**MEETING AGENDA
SESSION OF THE PLANNING ADVISORY BOARD
CITY OF KISSIMMEE
CITY HALL, COMMISSION CHAMBERS
101 CHURCH STREET, KISSIMMEE, FLORIDA 34741-5054
WEDNESDAY, DECEMBER 7, 2022 AT 6:00 PM**

5.A Public Hearing for a Conditional Use with Site Specific Redevelopment Plan to establish a child care facility at 820 Emmett Street - CU-22-0011

5.B Public Hearing for a Conditional Use with Site Specific Redevelopment Plan to establish an office conversion at 721 Mabbette Street - DRC-21-00055

5.C Public Hearing for a Conditional Use with Site Specific Redevelopment Plan to establish a 30 unit multi-family residential development at 511 Dillingham Avenue - CU-22-0010

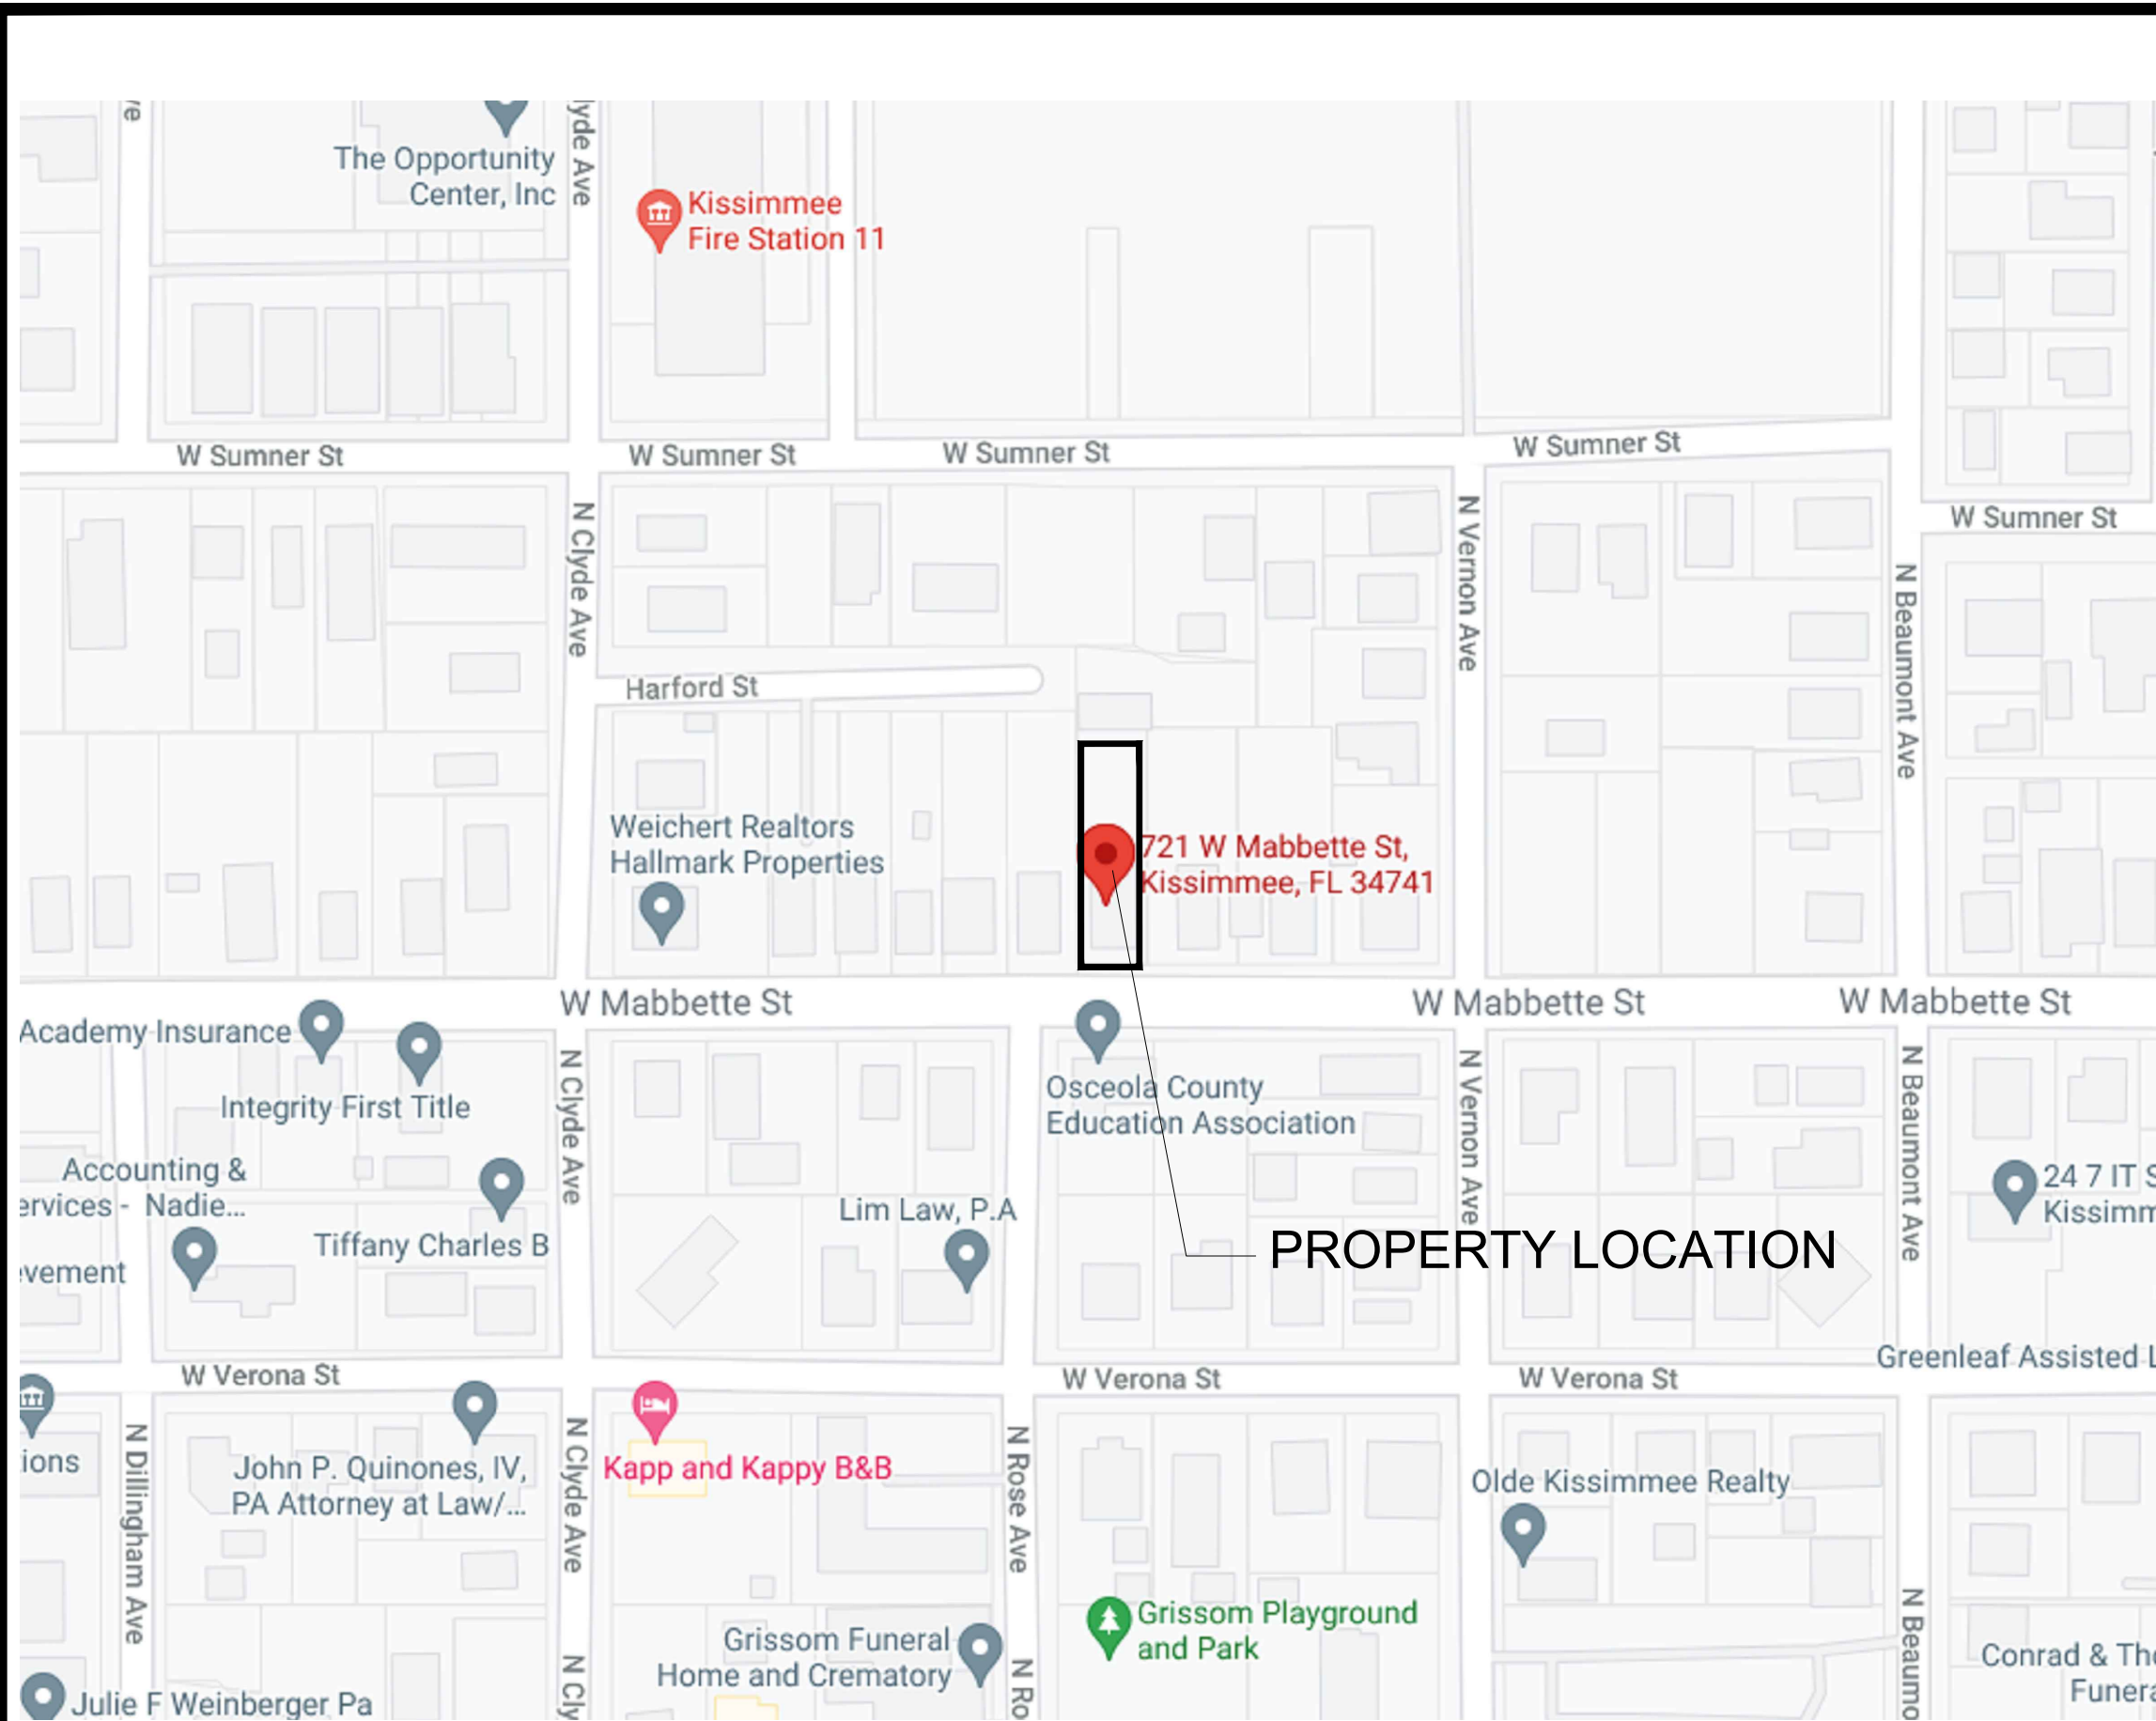
1. **Remove the ramp that connects to the sidewalk on Mabbette Street. Like other residential conversions in the area, the ramp should connect to the parking area and have a minimal impact to the integrity of the structure. The ramp should only connect to the parking area and shall not extend in front of the front facade.**
2. **Slats for the ramp shall match the style of other similar style improvements within the district and be consistent with slat styles appropriate for the bungalow style. Samples have been included as a reference.**
3. **The trash receptacles shall be moved to the rear of the structure and comply with any Land Development Code requirements for screening.**

4 FLOOR PLAN HANDICAP RAMP
A-8 SCALE 1/4" = 1'

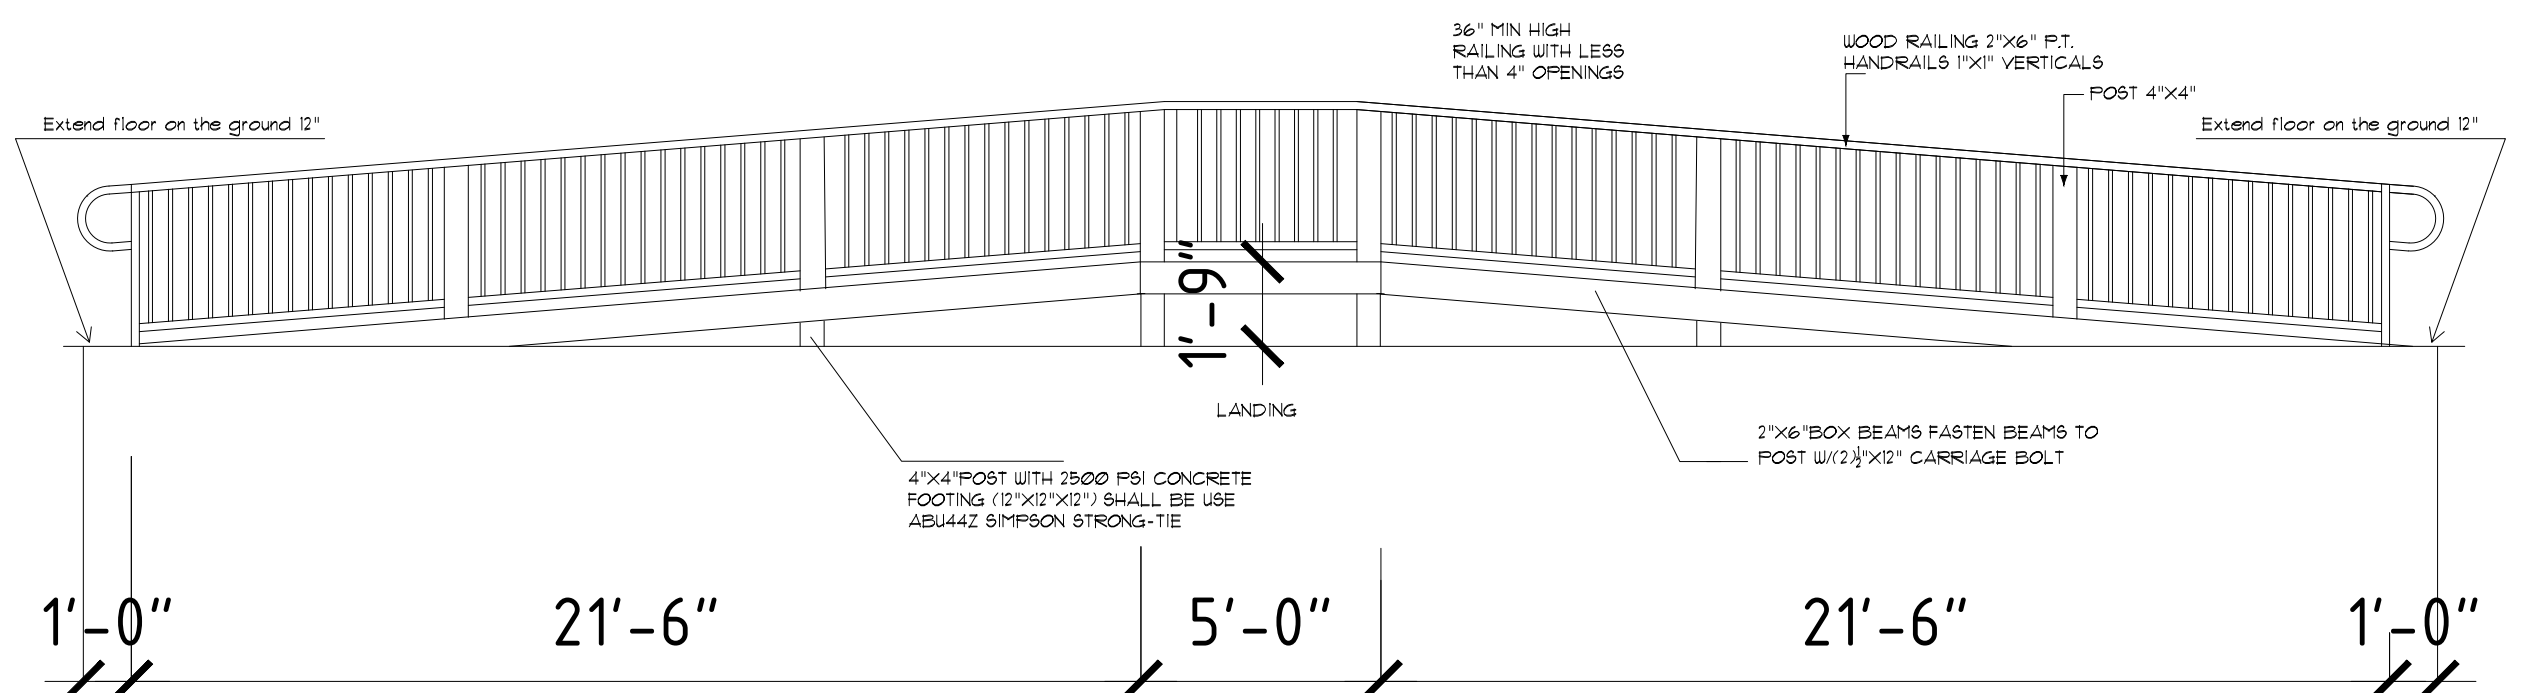
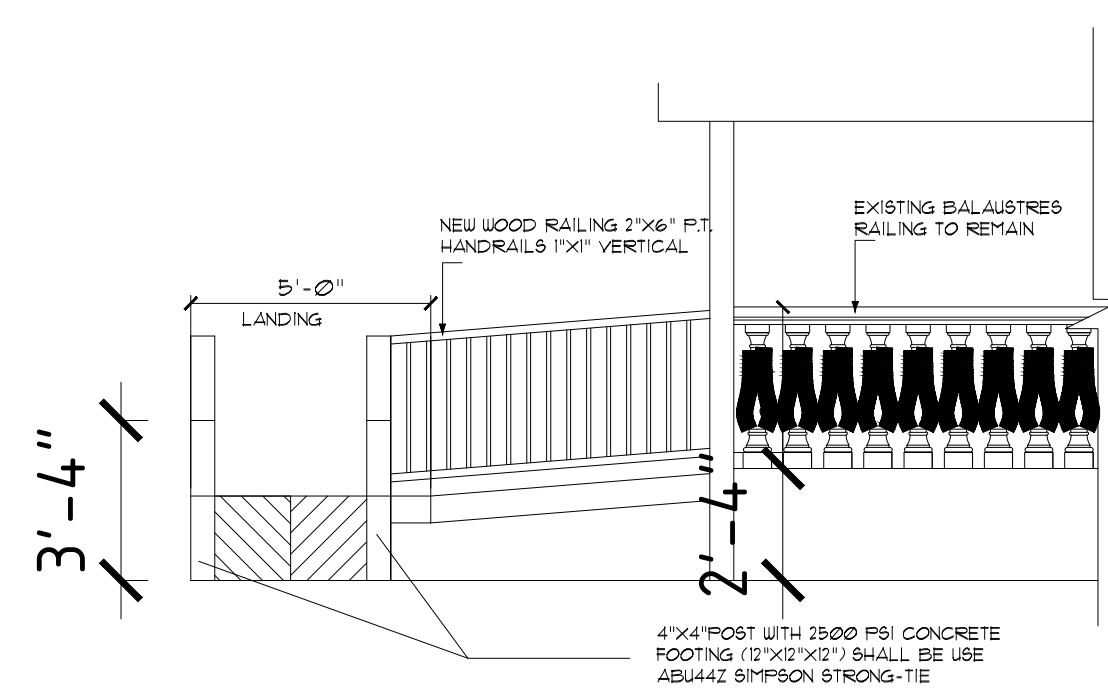
impact to the integrity of the structure. The ramp should only connect to the parking area and shall not extend in front of the front facade.

3. Slats for the ramp shall match the style of other similar style improvements within the district and be consistent with slat styles appropriate for the bungalow style. Samples have been included as a reference.
4. The trash receptacles shall be moved to the rear of the structure and comply with any Land Development Code requirements for screening.
5. Any changes to the approved work, including a change in work materials, must be presented to the Historic Preservation Board before starting or continuing with construction. Failure to do so will result in Code Enforcement Action.

Figure 5-27: Examples of Building and Roof Articulation

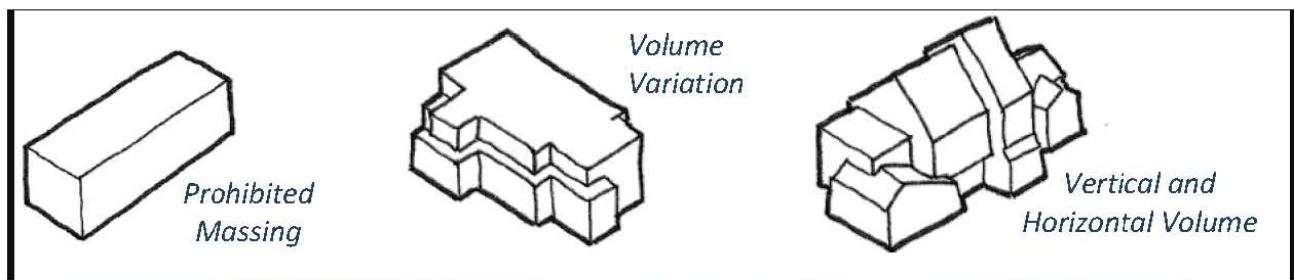
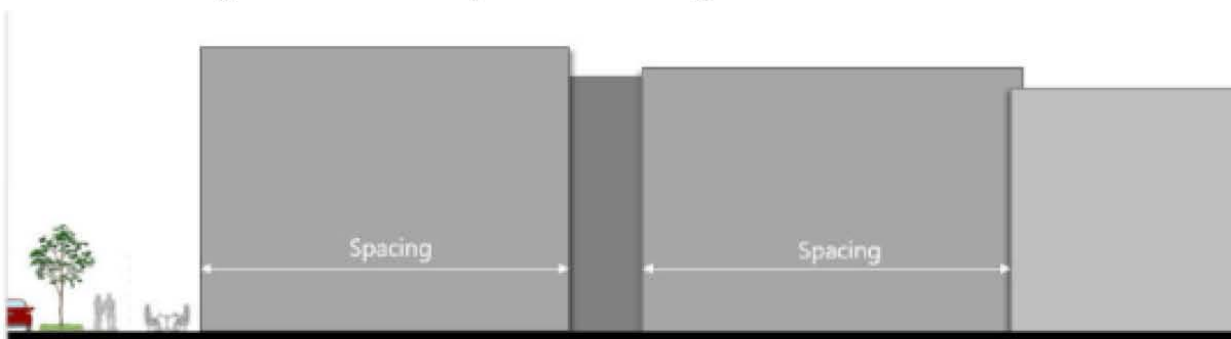
17. **Comment Partially addressed:** Include the ground floor ceiling height, upper floors ceiling height, and ground floor elevation on all facades on the elevation sheets consistent with the T4-R zoning requirements.

- a. The 2nd floor is not meeting the 9ft. minimum ceiling height (Table 5-2, 14-5-6)
18. **Addressed within Developer's Agreement:** Buildings on corner lots and buildings that terminate vistas shall incorporate distinctive architectural treatments to emphasize their prominent location. 14-5-7A(3)
